**Landscape Review Committee**  
**Community Development Center, 231 NE 5<sup>th</sup> Street**  
**September 18, 2019**  
**12:00 PM**

DATE: September 18, 2019  
TO: Landscape Review Committee Members  
FROM: Jamie Fleckenstein, Associate Planner  
SUBJECT: Street Tree Removal Application (L 18-19)

An application to remove two (2) street trees from the public right-of-way along NW 7<sup>th</sup> Street (L 18-19) to be reviewed by the Landscape Review Committee.

**Figure 3: Applicant's Site Plan**

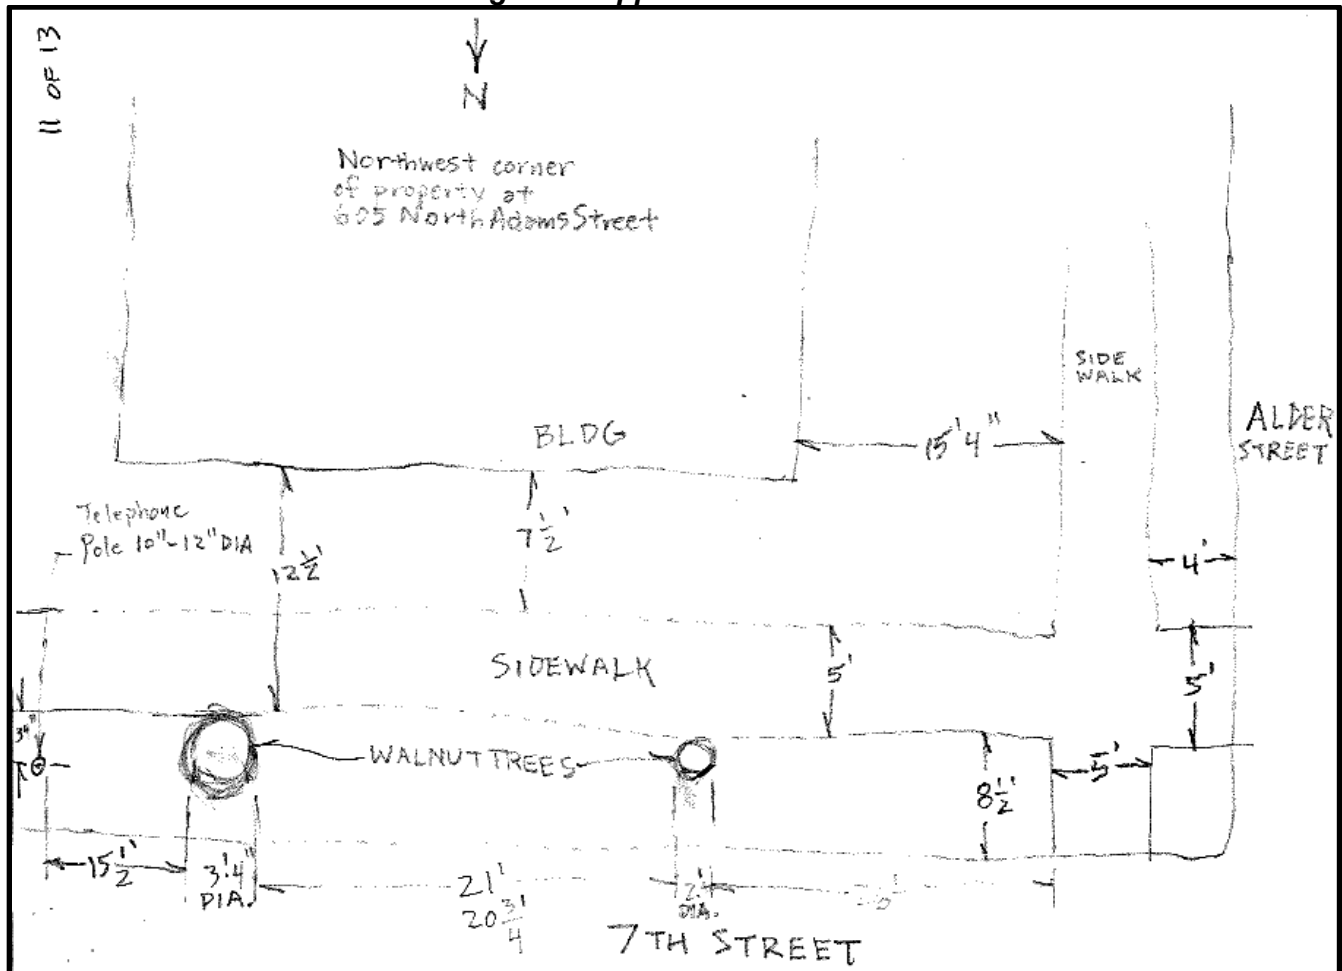
The easternmost tree is approximately 36 inches in diameter at breast height (DBH). The tree is exhibiting significant die-back in the canopy, indicative of declining health. Several large dead limbs can be seen in the crown of the tree. Large surface roots are present throughout the planting strip, and have lifted the adjacent sidewalk panels approximately seven (7) to eight (8) inches above grade causing large surface discontinuities. Attempts to repair the discontinuities have been made in the past, but continued growth of the tree and roots further lift the sidewalk panels and limit the effectiveness of the repairs. The tree has also grown into overhead utility lines.

The westernmost tree, approximately 24 inches DBH, is also experiencing dieback on the canopy. Large surface roots have lifted adjacent sidewalk panels creating surface discontinuities. The tree is beginning to grow into and over the adjacent sidewalk due to its placement in the planter strip. This tree has also grow into overhead utility lines.

Between the current disruption of the path of travel in the public right-of-way created by the lifting of the adjacent sidewalk, the tree branches growing into and above the overhead utility lines, and the excessive littering of the right-of-way with fruit and nuts causing slip/trip/fall hazards to pedestrians, the trees meet the criteria for tree removal permit approval because they are in conflict with public improvements. Additionally, it is apparent from the significant dieback in the canopies of the trees that their health is decline, possibly from Thousand Canker Disease. The risk of failure of large tree limbs will continue to increase as the dieback continues.

**Figure 3: Applicant's Site Plan****Attachments:**

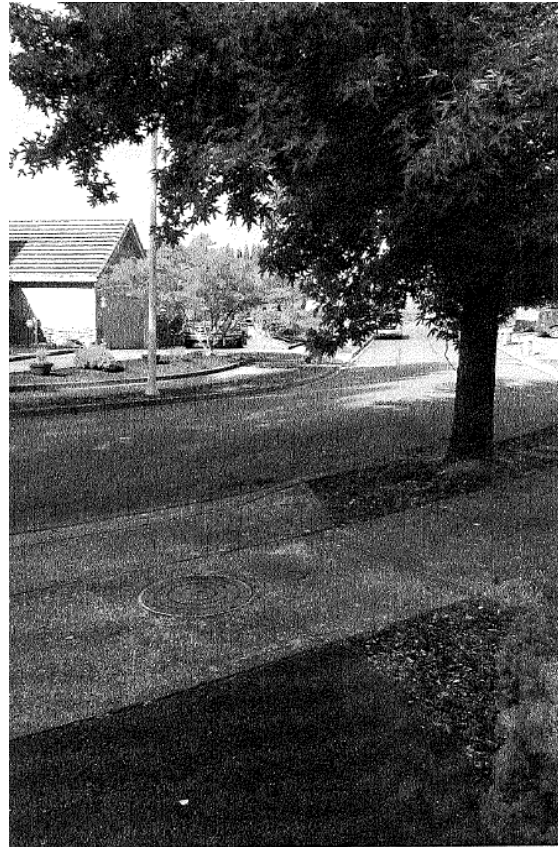
The subject tree is a *Liquidambar styraciflua* (American Sweetgum) which are generally considered to be problematic street trees due to excessive and prolonged fruit drop creating slip/trip/fall hazards in the right-of-way below and an aggressive, shallow root system known for lifting concrete sidewalk panels. *Liquidambar styraciflua* is specifically identified as a "Prohibited Tree Species" on McMinnville's Street Tree List. The tree proposed for removal is lifting the adjacent sidewalk panels and causing disruption to the nearby water meter boxes. The tree is in conflict with public improvements and is a prohibited street tree species, meeting the criteria for approval of the removal request.

The tree is currently spaced three (3) feet from the adjacent water meters and six (6) feet from the driveway. Current City street tree spacing standards are ten (10) feet from water meters and five (5) feet from private driveways. Because there is no location in the planting strip between the water meters and the driveway where a street tree could meet the spacing standard from water meters, a replacement street tree is not recommended.

**Figure 5: Landscape Plan Enlargement – NE Adams Street & West Parking Area**

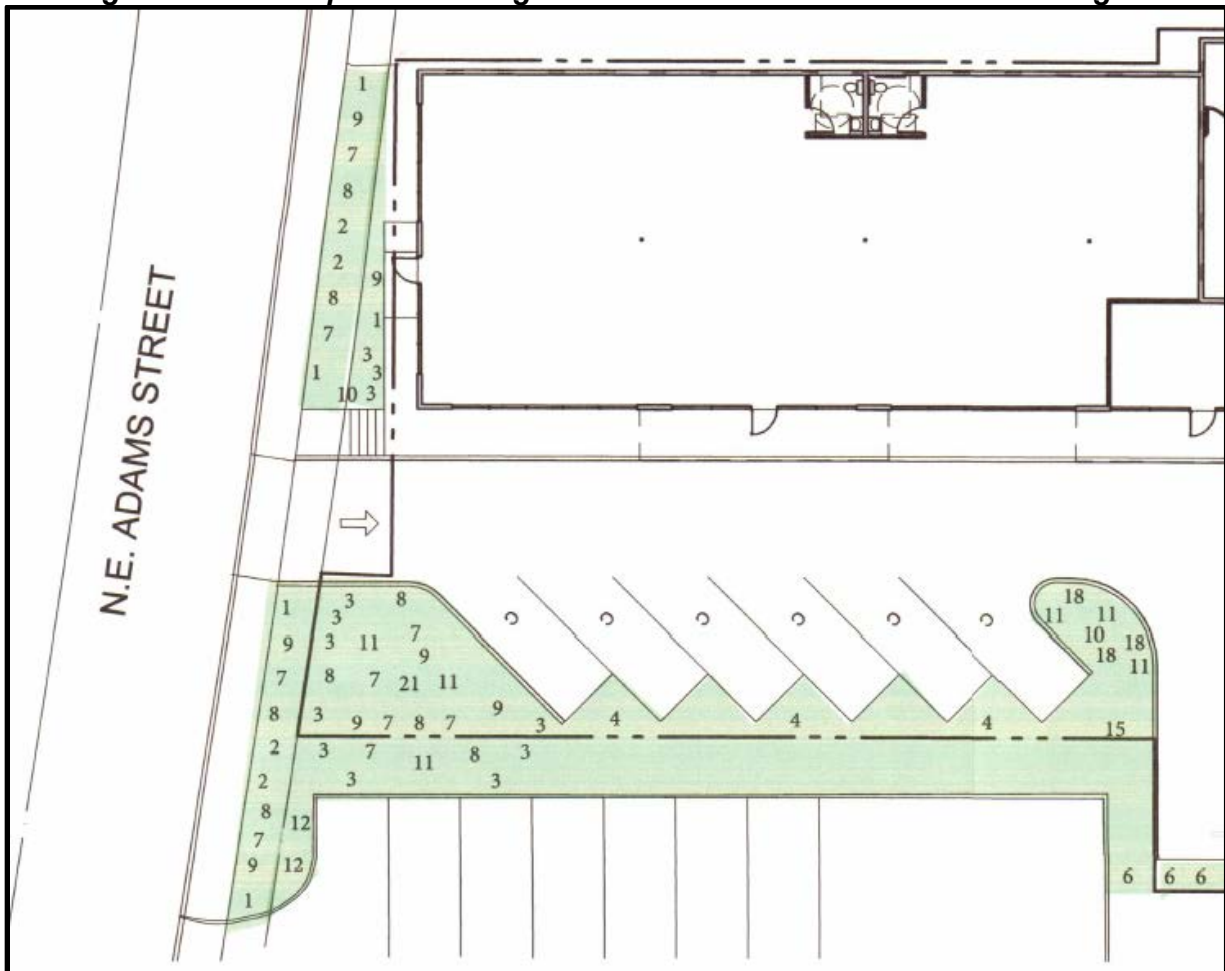
Two (2) Leyland Cypress trees are proposed in the planting area west of the adjacent parking lot to the south of the site. The planting area is eight (8) feet wide, with planting described above in the right-of-way. Leyland Cypress are dense evergreen conifers, and are branched to the ground. They reach up to 70 feet in height and 15 to 25 feet in width. The plant selection does not seem appropriate for the location – the trees would quickly outgrow the space provided, and would obstruct the clear vision triangle required for a commercial driveway. A condition of approval is included to substitute the Leyland Cypress for either a smaller plant that would remain below three (3) feet in height or a different tree that can be limbed up to a minimum of eight (8) feet above grade to maintain clear vision of oncoming traffic on NE Adams Street when exiting the existing parking lot

**Figure 6: Landscape Plan Enlargement – NE Baker Street & South Parking Area**

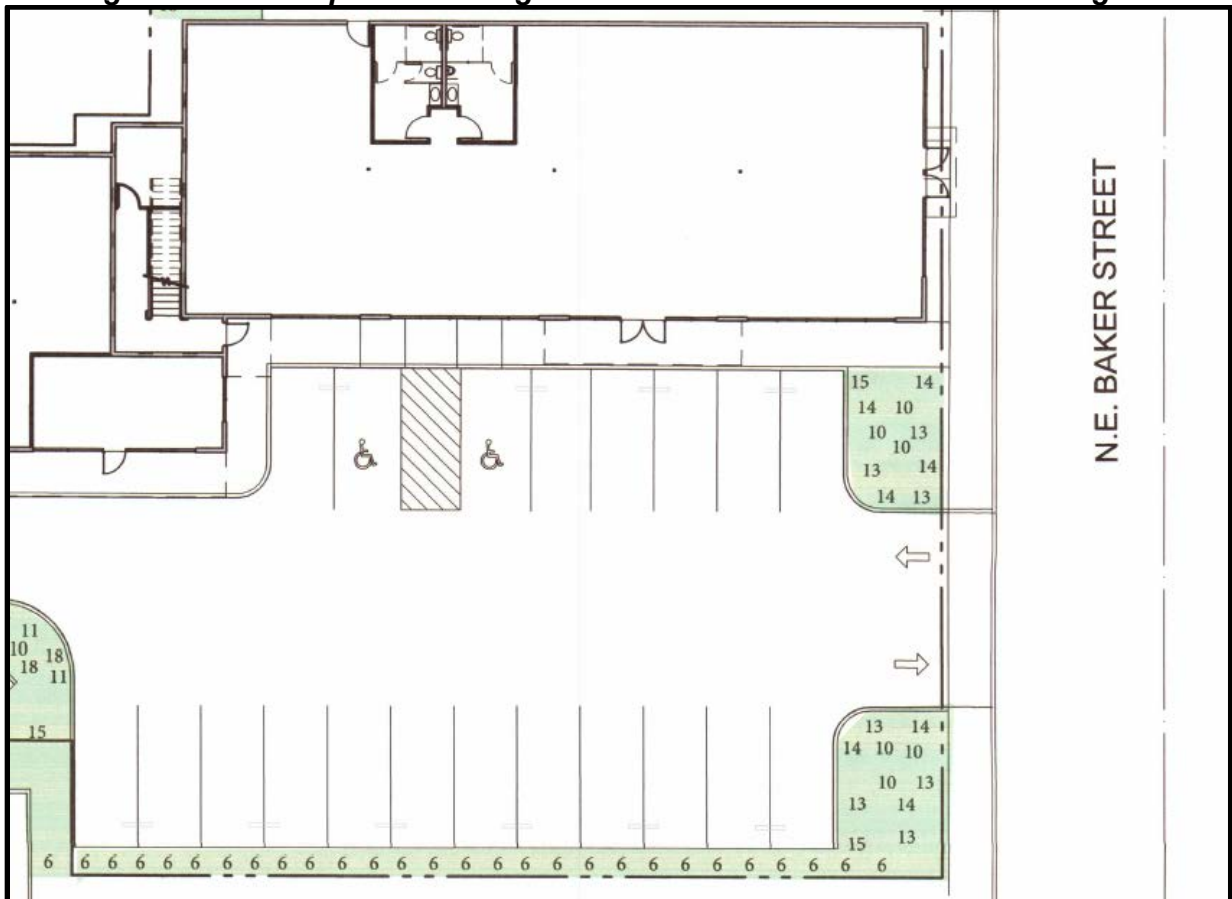
A continuous hedge of Victoria Ceanothus spaced at four (4) feet on center is proposed in a four (4) foot wide planting bed. Victoria Ceanothus is an evergreen flowering shrub that grows six (6) to nine (9) feet tall and 10 to 12 feet wide. The proposed species would seem too large for the space provided, and quickly grow over the property line and into the required parking spaces. A condition of approval is included to substitute the Victoria Ceanothus with a different evergreen hedge plant more appropriately sized for the size of the planting bed.
